Request for additional information - Development Application No. DA/1146/2020 - Demolition of structures and the Torrens title subdivision of one lot into ten including a voluntary planning agreement for road acquisition - Lot 18 DP 16975, No. 90-92 Franklin Road, CHERRYBROOK NSW 2126

1. Amended Subdivision Plan

Attachment 1 – Initial Environmental Review

Attachment 2 - Concept Options 1 and 2

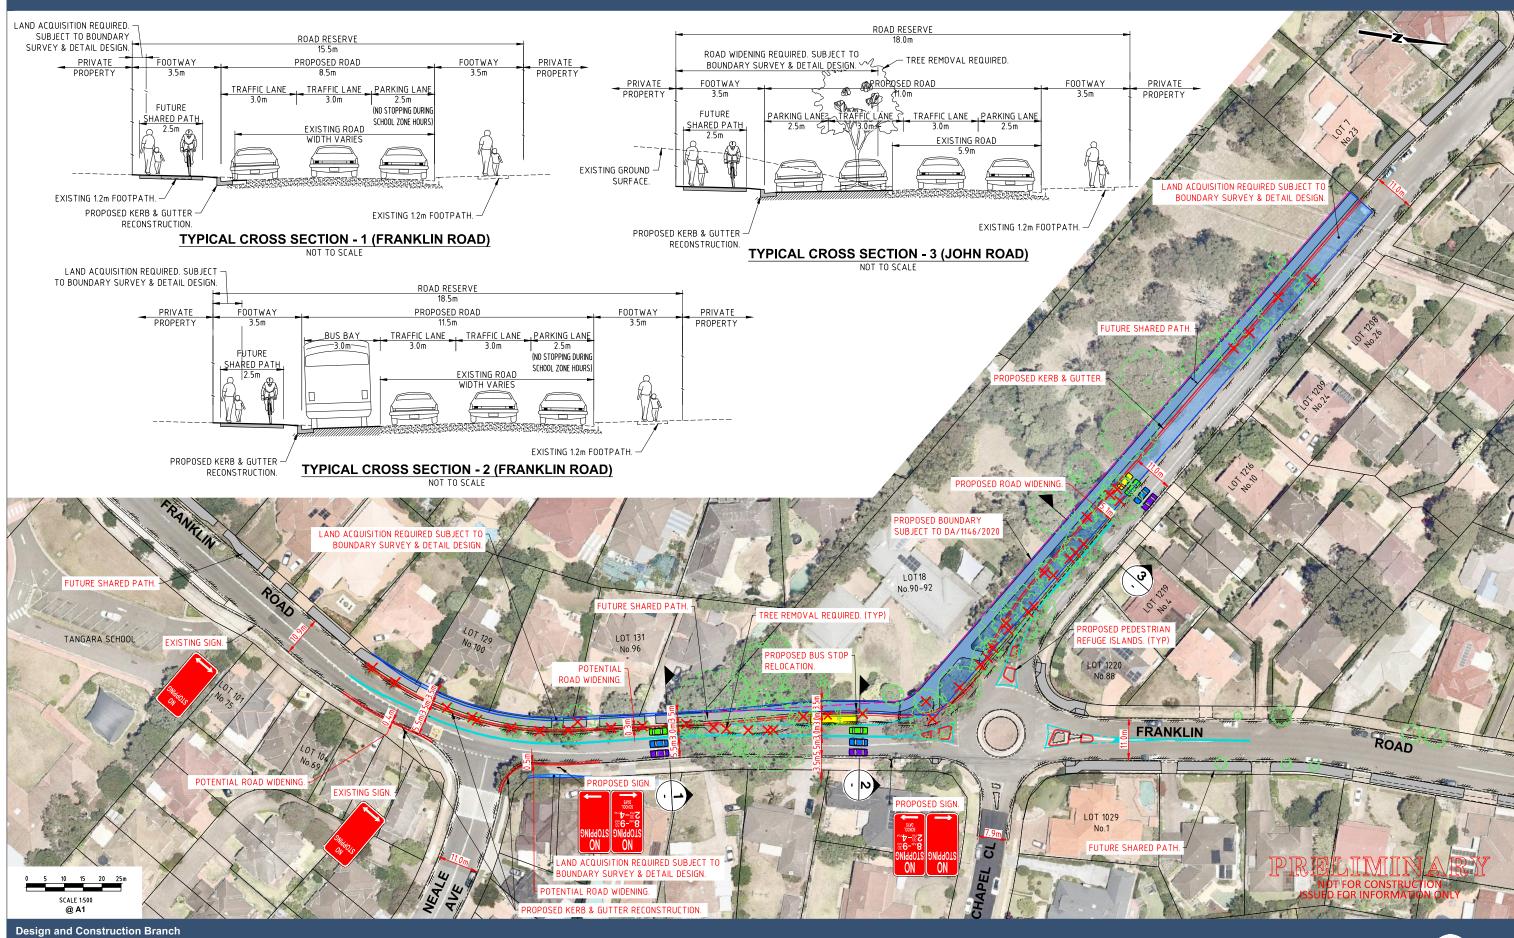
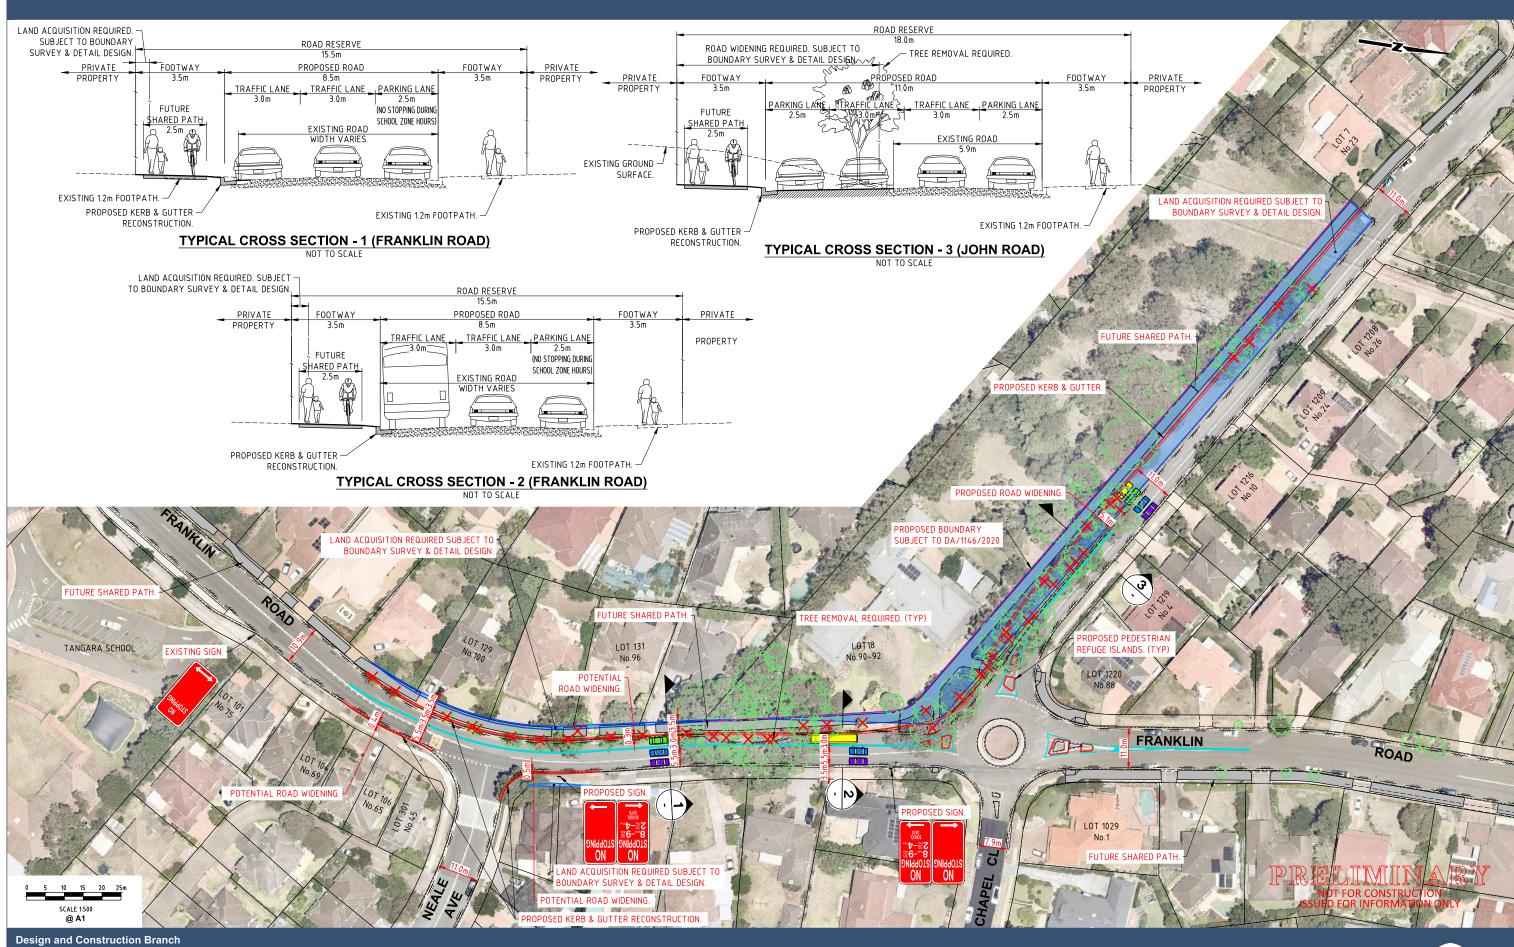
As discussed in the meeting with Council officers on 5 August 2022, Council has undertaken a full design review of potential road widening options for John and Franklin Roads. This review has identified two preferred design options, which are identified as Option 1 and 2.

Options 1 and 2 would involve widening John Road reserve (from 10m to 18m) and Franklin Road reserve (from 15m to 15.5m or 18.5m) to meet current road design standards. The primary difference between the two concepts is option 1 would include a bus bay outside No.90-92 Franklin Road (i.e. wider 18.5 m road reserve) that would allow northbound motorists to pass a stopped bus.

Option 1 has superior road safety impacts and would improve traffic flows, however it would require acquisition of additional land beyond the currently identified portion for road widening. The additional land required to facilitate the construction of Option 1 is minimal, with the exact area to be identified upon detailed survey / design work being undertaken.

Council would appreciate full consideration of design Options 1 and 2, with the identification from the applicant as to the preferred option to progress, including detailed reasoning as to why this option has been chosen. Further Council feedback can be provided upon request.
